SUBJECT: SAFETY EVALUATION REPORT FOR THE CROWNPOINT URANIUM MINING  
PROJECT

**HYDRO RESOURCES, INCORPORATED  
LICENSE APPLICATION FOR  
CROWNPOINT URANIUM SOLUTION MINING PROJECT  
MCKINLEY COUNTY, NEW MEXICO**

**DOCKET NO. 40-8968**

Figure 1. HRI Organization Chart.

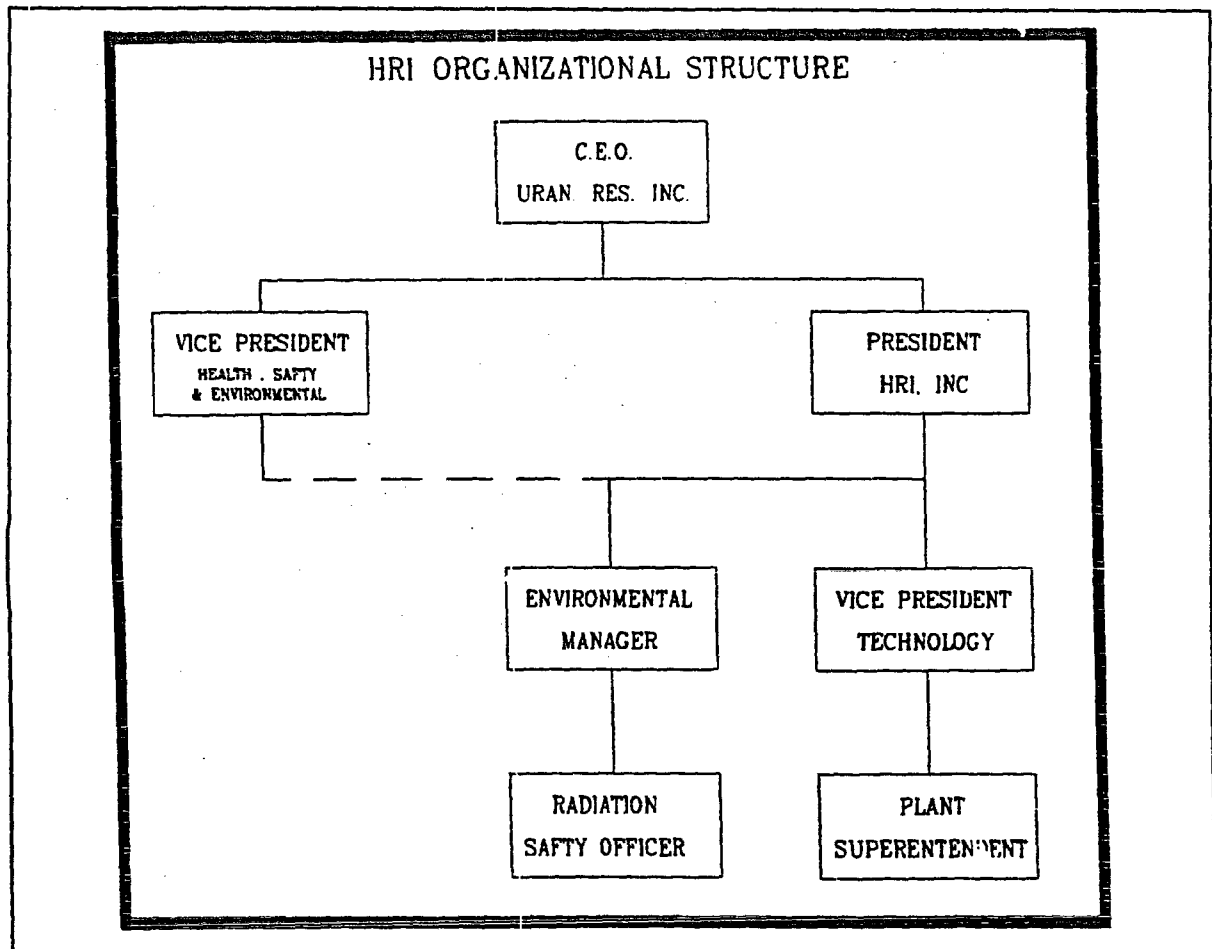
Figure 1 is a partial organization chart of HRI's Crownpoint Project. The positions and duties of HRI personnel are described below, in descending order of authority. Qualifications and experience requirements are noted, where applicable. HRI will allow a Master's degree in an appropriate field to equate to two years of work experience. HRI's organizational arrangement is consistent with Regulatory Guide 8.31 (NRC 1983b). The organizational arrangement allows radiation safety matters to be considered at any management level. To ensure clear lines of communication for radiological safety matters, NRC will require by license condition that:

**Any corporate organization changes affecting the assignments or reporting responsibilities of the radiation safety staff as described in the COP of the approved license application shall conform to Regulatory Guide 8.31 (NRC 1983b).**
